ALERT SERVICE BULLETIN

412-00-100

Revision B, 23 April 2024

SUBJECT: CAP ANGLE, P/N 212-030-191-001, INITIAL INSPECTION

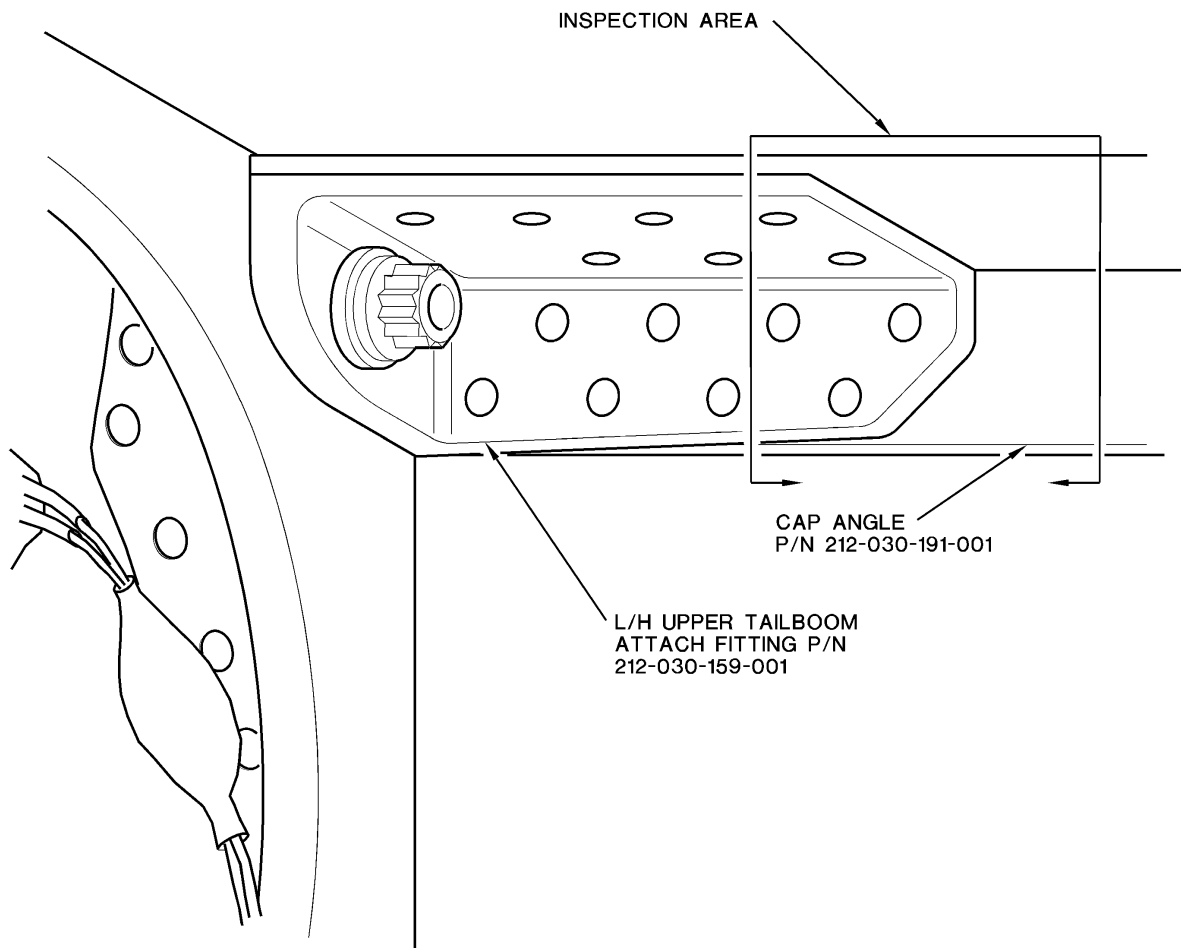
1. Gain access to the cap angle in the tail rotor servo compartment through the R/H aft fuselage door.
2. Inspect area noted on [figure 1](#) of cap angle, P/N 212-030-191-001, with 10x magnifying glass.
3. If no cracks are found, return the aircraft to service.
4. If a crack is found, contact Product Support Engineering before further flight:
